ADDENDUM NUMBER 02

**ARPA- CAMPGROUND EXPANSION PROJECTS
A FEDERAL AID PROJECT**

PAWTUCKAWAY STATE PARK

DIVISION OF PUBLIC WORKS PROJECT NUMBER 81205R

Title
BATHHOUSE 7
EXISTING CONDITION
GENERAL LEGEND & NOTES
Sheet Number:
C1.03

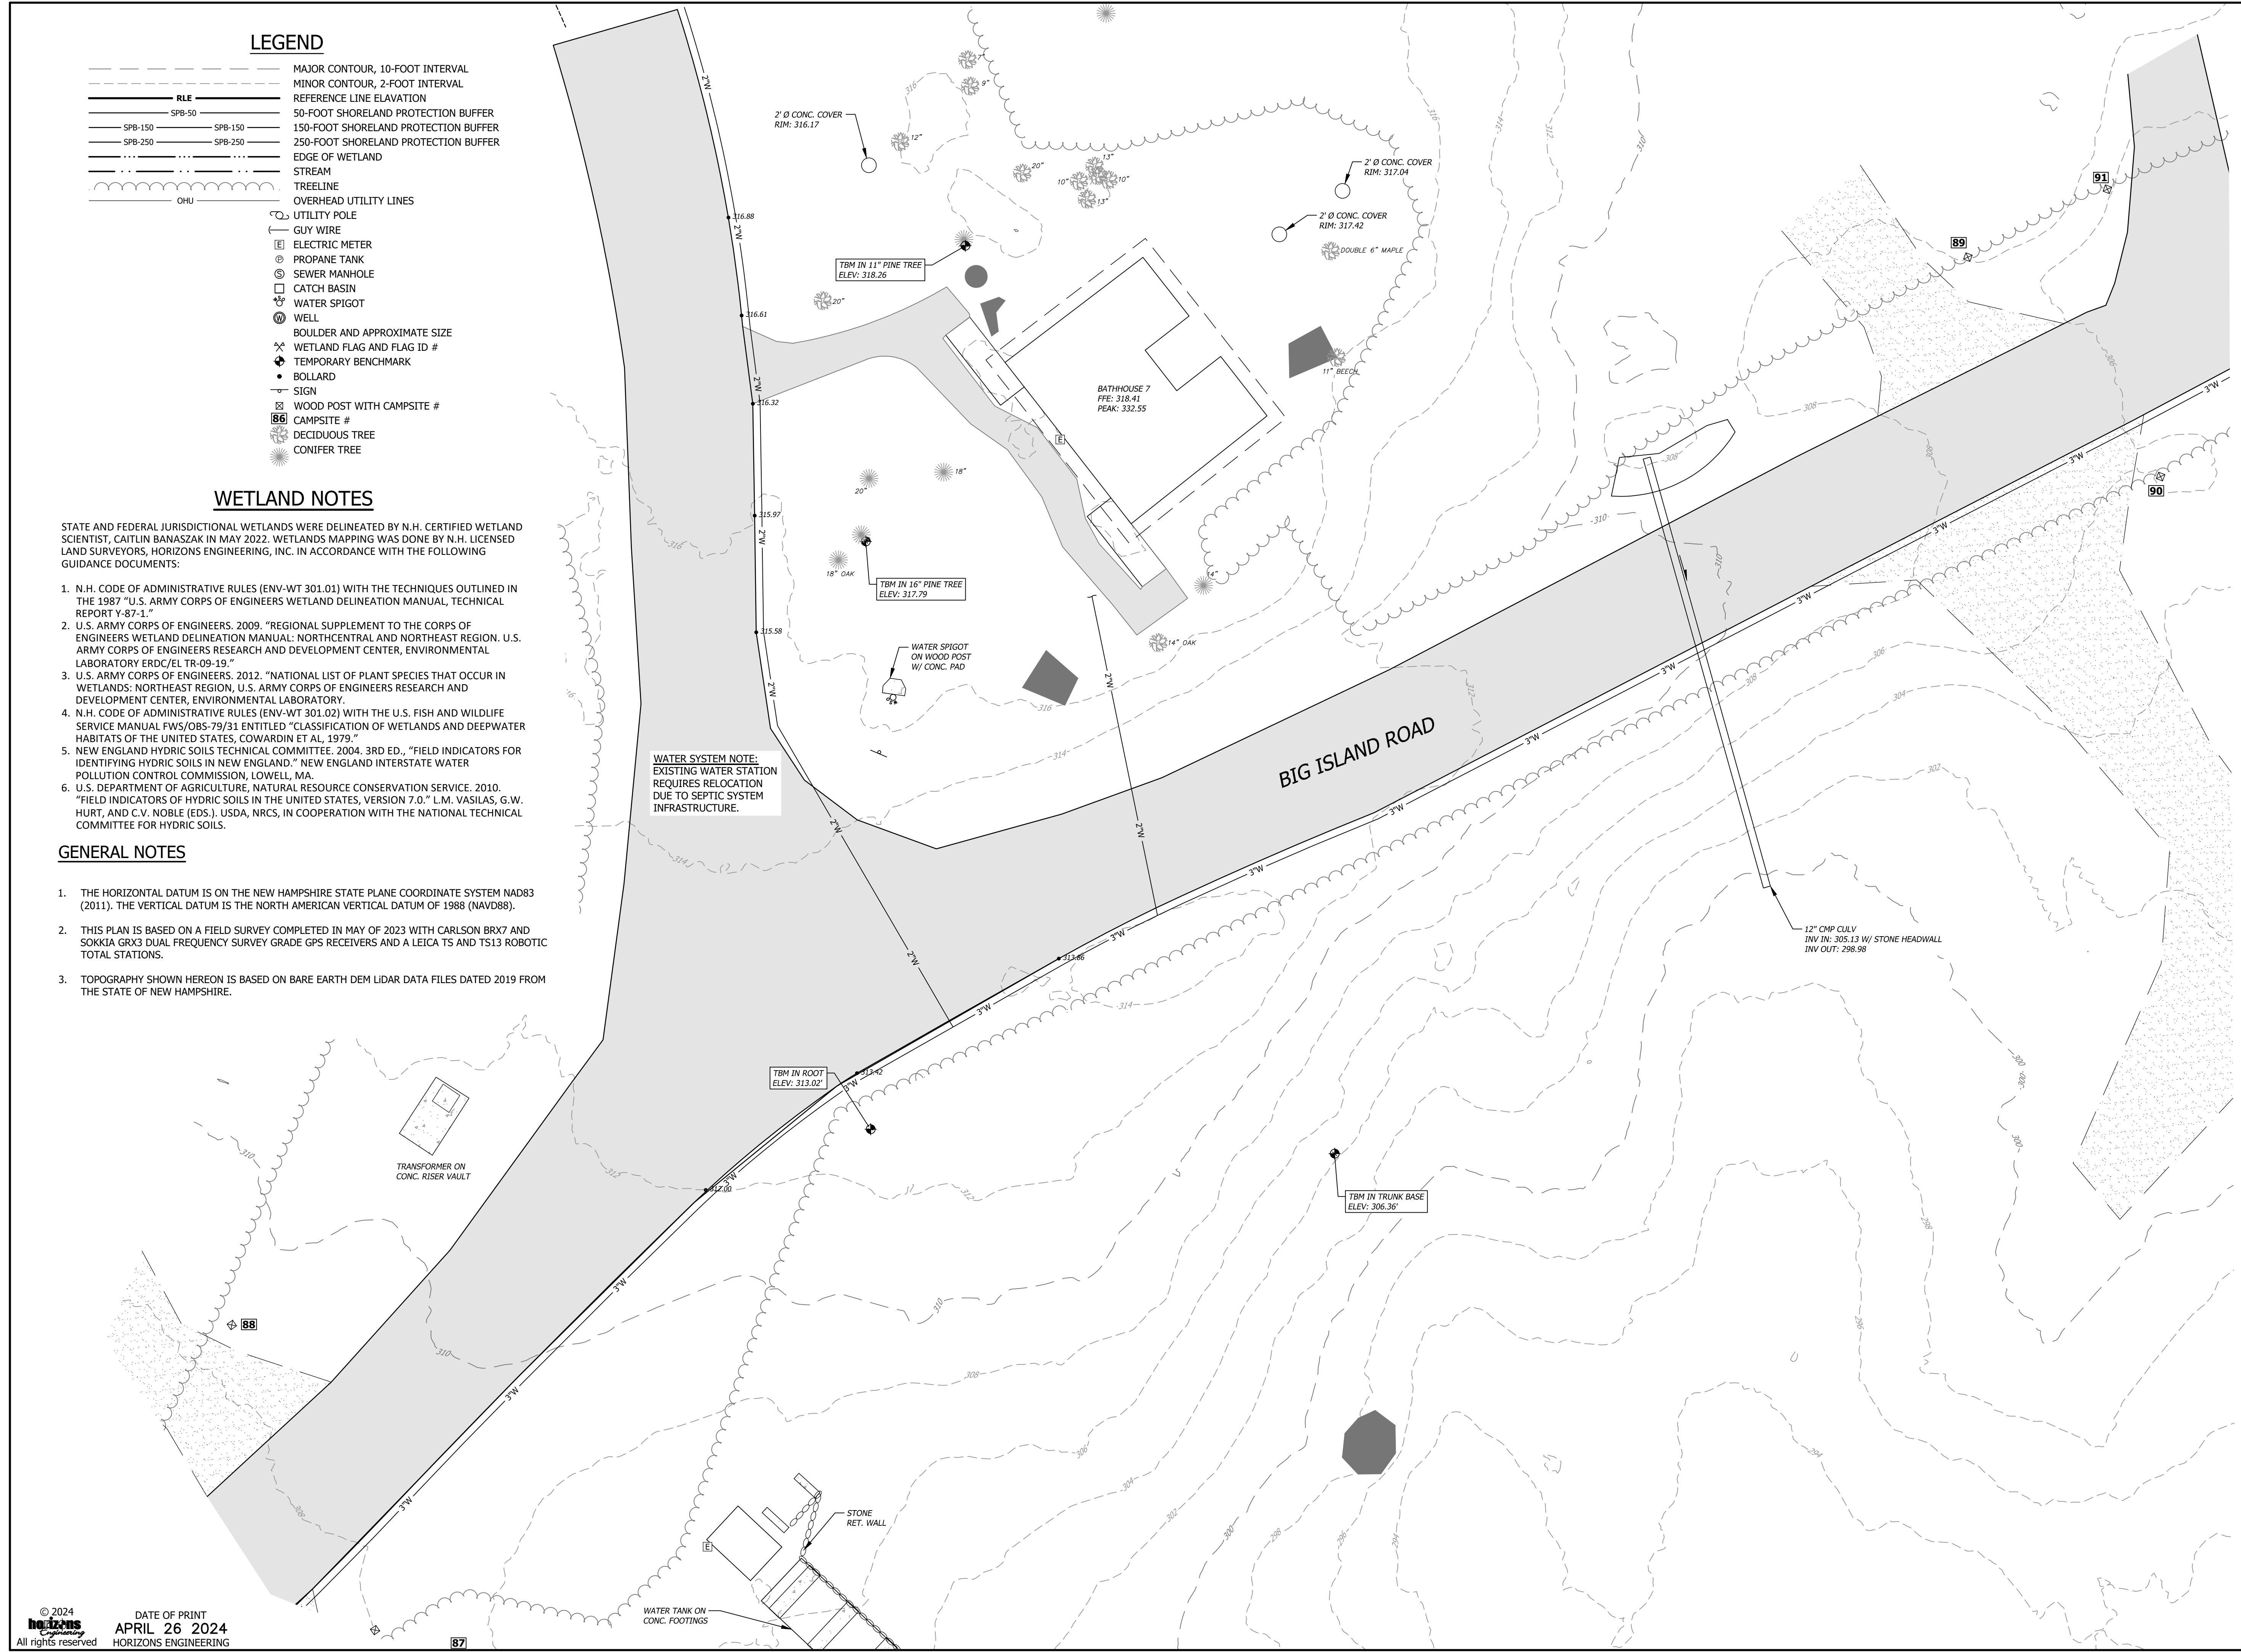
4. Revised approximate existing tree line.

18. Question: Indicate existing tree line at and around Bath House #7.
Response: *See approximate tree line on revised sheet C1.03.*

Sheet Number:
C3.05

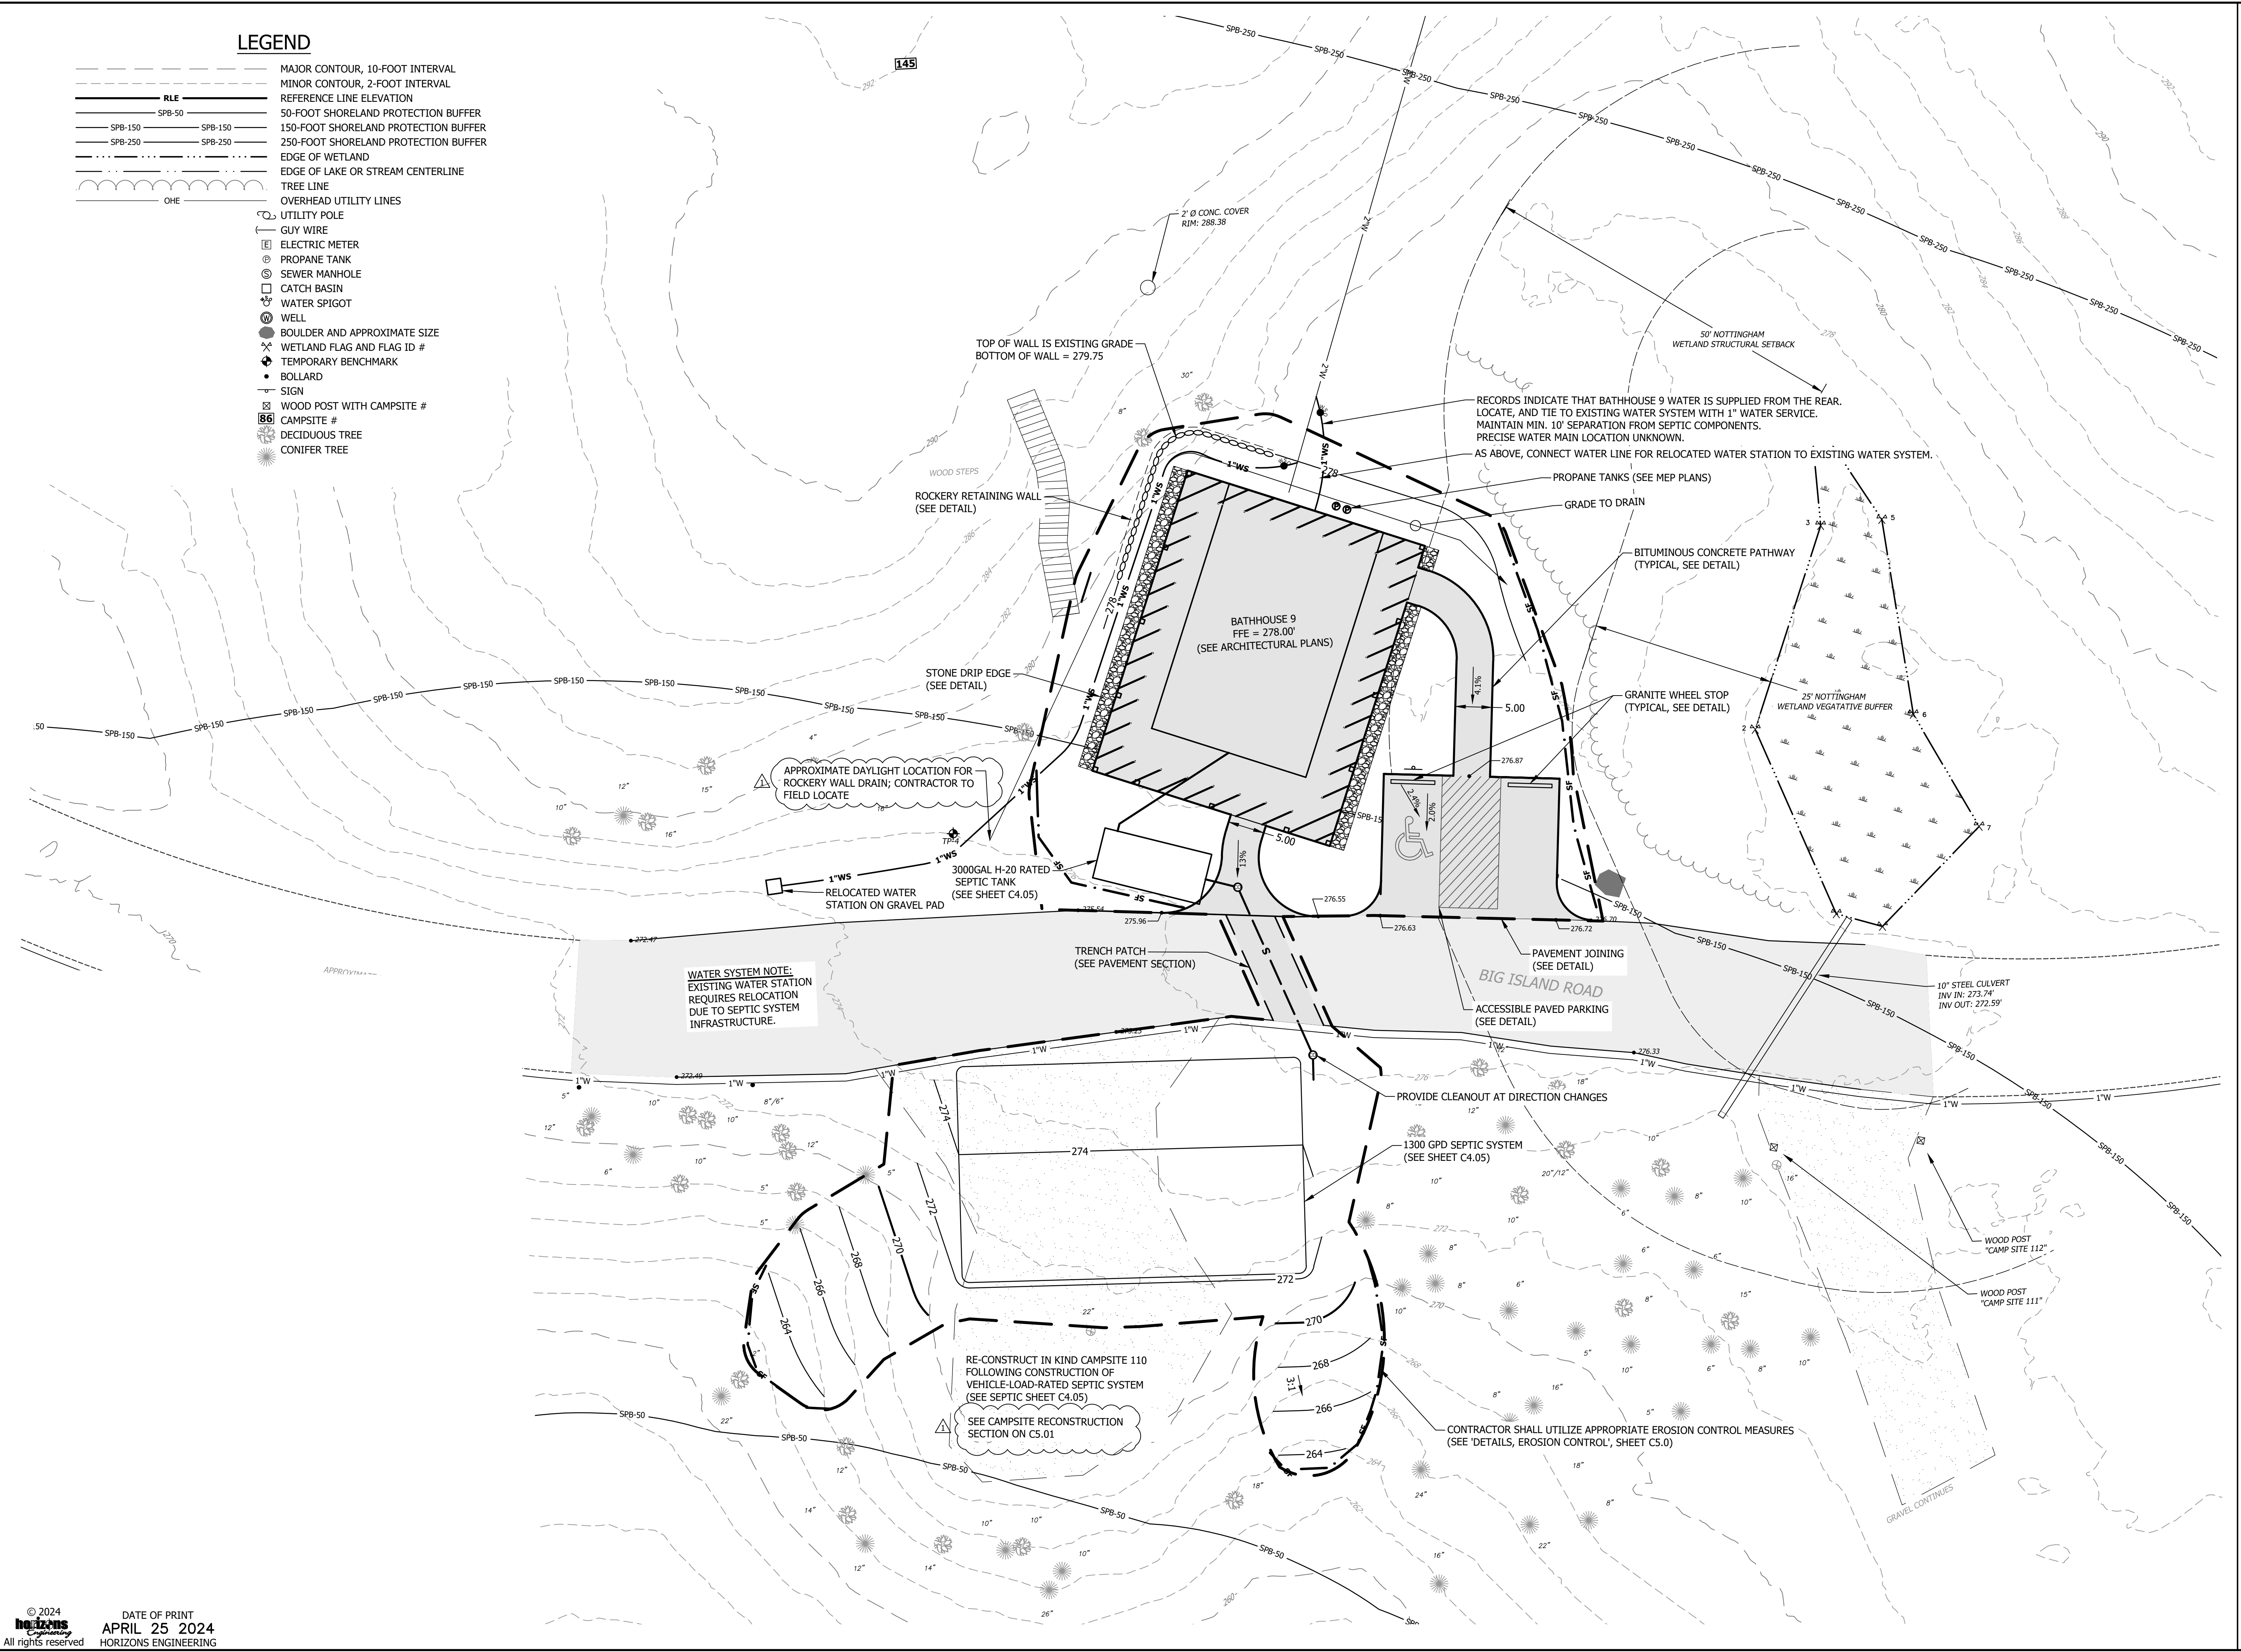
5. Added approximate daylight location for rockery wall drain.
6. Added note to see campsite reconstruction section on sheet C5.01.

29. Question: Identify point of connection for the 4" perf. PVC pipe at the "Rockery Walls".
Response: *See revised sheet C3.05 for routing of rockery wall drains to daylight.*
